**SAFETY  
RECALL**

**SR23-05**

DATE :	September 2023	SECTION :	23 ACCESSORIES
SUBJECT:	AFSS OPTICAL SENSOR CORROSION

**AREA OF THE SENSOR BACKSIDE THAT MUST BE FREE OF CORROSION (WHITE ALUMINUM OXIDE POWDER)**

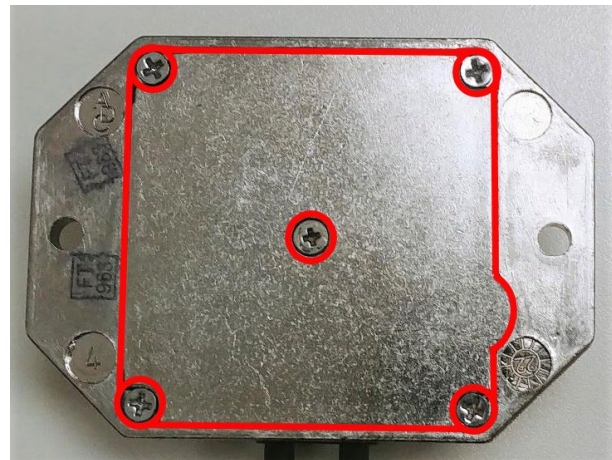
4. Inspect the backside of the sensor looking for sign of corrosion at the cover seam.

- Look for excess of aluminum oxide, a white (sometimes greenish) dusty looking material.
- If aluminum oxide is found and it is touching the seam of the backside cover, the sensor must be replaced.
- Superficial black spots (small crater) are ok unless they create a noticeably deep crevice at the seam area.

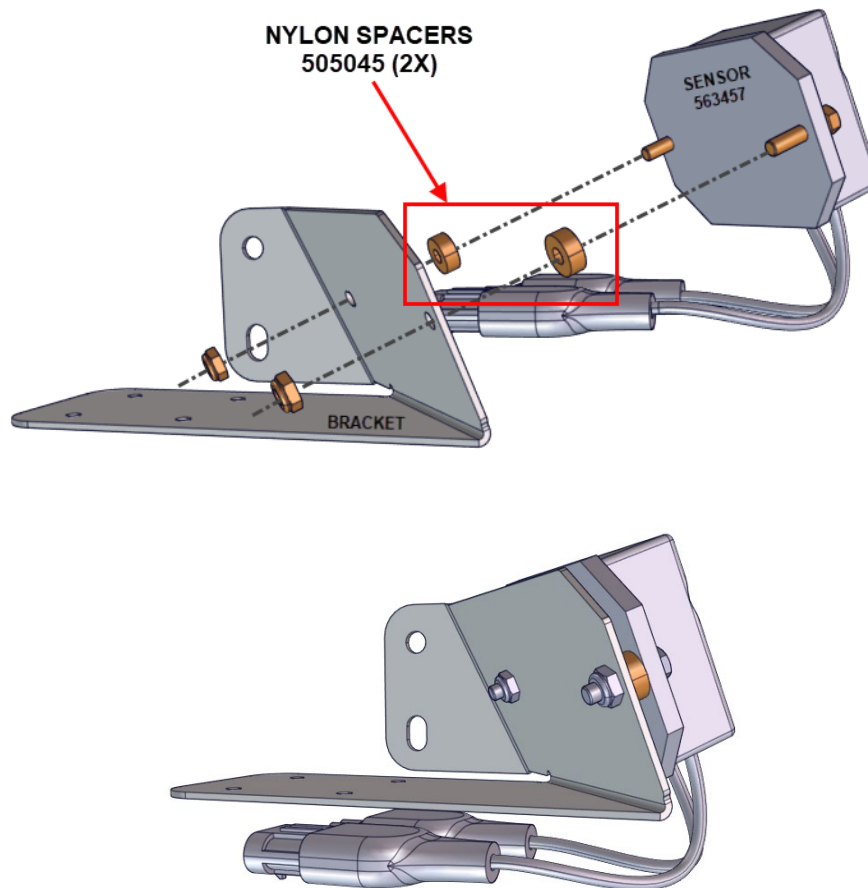
7. Reinstall (or install a new sensor, as required) the sensor on the bracket adding the supplied **505045** nylon spacers between the sensor and the bracket.

- Reuse mounting hardware (screws and nyloc nuts).
